Product change notification

DRL

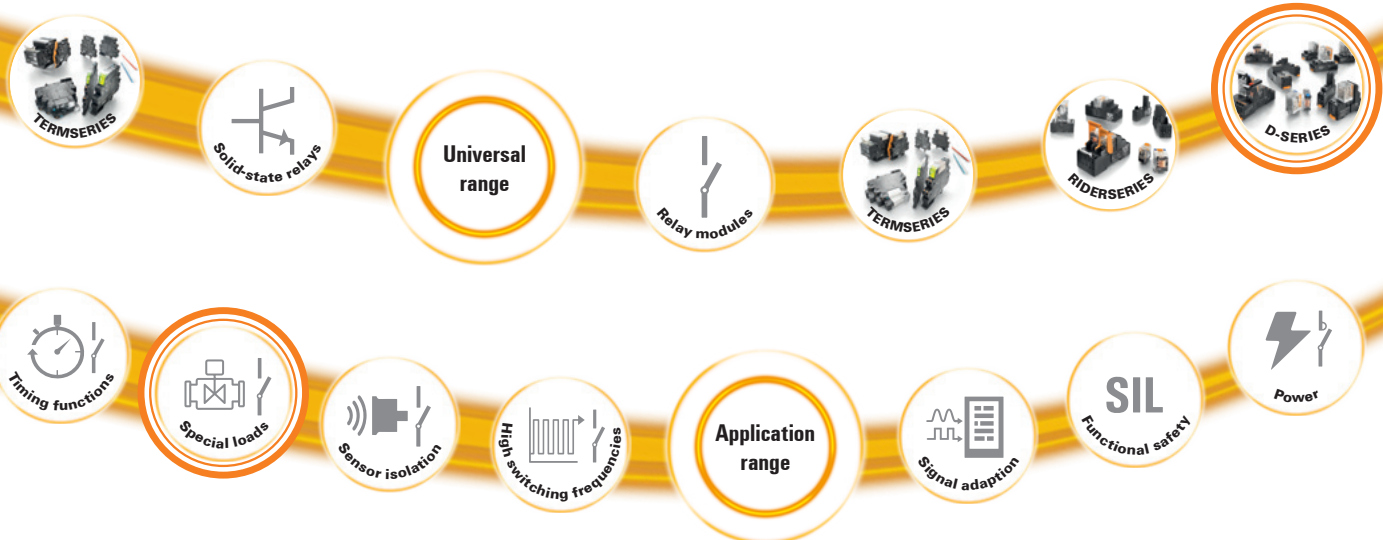
This article uses an exemption named in Annex III of the RoHS Directive 2011/65/EU "8b - Cadmium and cadmium compounds in electrical contacts", which could only be valid until 21.07.2021, depending on the product category. Please check whether you can use this article depending on the place of marketing and the product category concerned

The miniature power relays of the D-SERIES DRL are available from 24 mm width. They have wear-resistant contact material for reliable switching of inductive loads. The product quality stays the same with the new contact material AgSnO2.

Type	Contact material	Order No.
DRL173012L	AgSnO2	2765100000
DRL173024L	AgSnO2	2765110000
DRL173048L	AgSnO2	2765120000
DRL173110L	AgSnO2	2765130000
DRL173220L	AgSnO2	2765140000
DRL173524L	AgSnO2	2765370000
DRL173615L	AgSnO2	2765380000
DRL173730L	AgSnO2	2765390000
DRL273012L	AgSnO2	2765150000
DRL273024L	AgSnO2	2765160000
DRL273048L	AgSnO2	2765170000
DRL273110L	AgSnO2	2765180000
DRL273220L	AgSnO2	2765190000
DRL273524L	AgSnO2	2765400000
DRL273615L	AgSnO2	2765410000
DRL273730L	AgSnO2	2765420000
DRL373012L	AgSnO2	2765210000
DRL373024L	AgSnO2	2765220000
DRL373048L	AgSnO2	2765230000
DRL373110L	AgSnO2	2765240000
DRL373220L	AgSnO2	2765250000
DRL373524L	AgSnO2	2765430000
DRL373615L	AgSnO2	2765440000
DRL373730L	AgSnO2	2765450000
DRL573012L	AgSnO2	2765260000
DRL573024L	AgSnO2	2765270000
DRL573048L	AgSnO2	2765280000
DRL573110L	AgSnO2	2765290000
DRL573220L	AgSnO2	2765300000
DRL573524L	AgSnO2	2765460000
DRL573615L	AgSnO2	2765470000
DRL573730L	AgSnO2	2765480000
